PREVOST SAFETY RECALL SR22-05 NHTSA SAFETY RECALL #22E-030 December 2023

# **IMPORTANT SAFETY RECALL – THIRD NOTIFICATION**

DEFECTIVE BELT IDENTIFICATION:

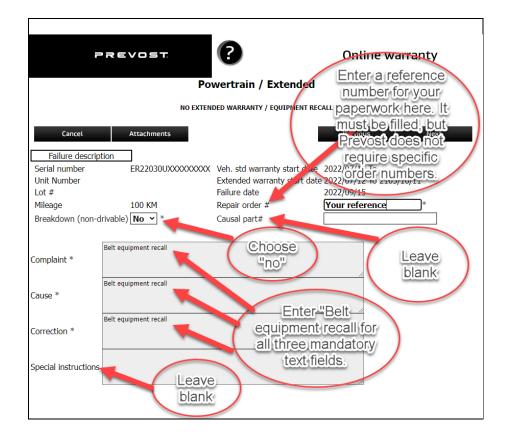
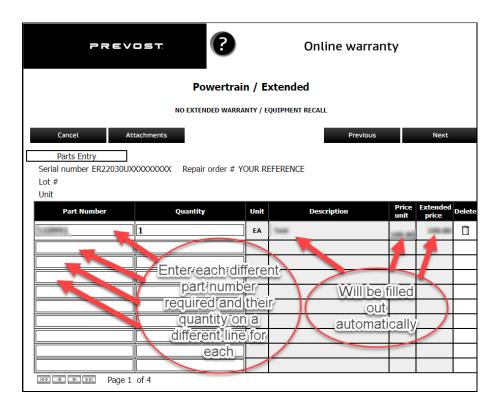
Defective Aramid cord reinforced belt (left) vs New polyester cord belt (right) – Note the different cord arrangement between the two belt types.

For all non-installed belts, new replacements are now available through the Prevost Part network (see appendix 1 for defective belt vs new belt identification).
